**INITIAL STATEMENT OF REASONS
FOR
PROPOSED BUILDING STANDARDS
OF THE
OFFICE OF THE STATE FIRE MARSHAL**

**REGARDING THE 2016 CALIFORNIA RESIDENTIAL CODE,
CALIFORNIA CODE OF REGULATIONS, TITLE 24, PART 2.5**

2016 INTERIM RULEMAKING CYCLE

Figure 1- Multipurpose System 2.5 gpm example.

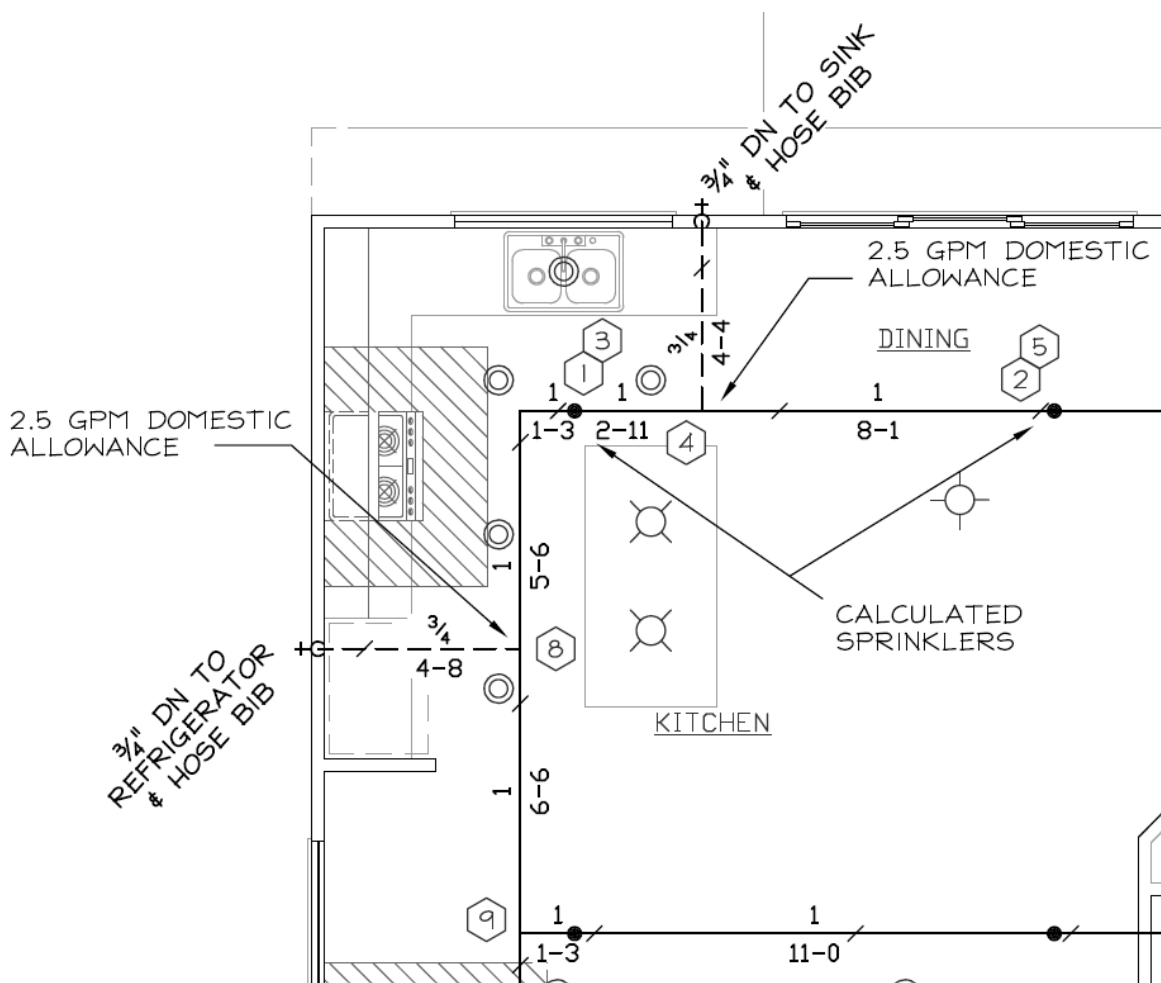
When performing hydraulic calculations of residential fire sprinkler systems, Section R313.3.5 of the CRC requires 5 gpm to be added to where the systems are interconnected. There has been confusion among the licensed design professionals and enforcing agencies on where the 5 gpm should be added on multipurpose systems’ calculations.

After evaluating the original intent of the amendment to CRC Section R313.3.5, the current Working Group determined 2.5 gpm should be added to each of the two remote plumbing fixtures on multipurpose systems. This requirement would match the original intent of the 5 gpm for standalone sprinkler systems that share a water supply. Figure 1 shows an illustration of a multipurpose system. It shows the two sprinklers used in the calculations and the two locations where 2.5 gpm are being added to the plumbing fixtures.
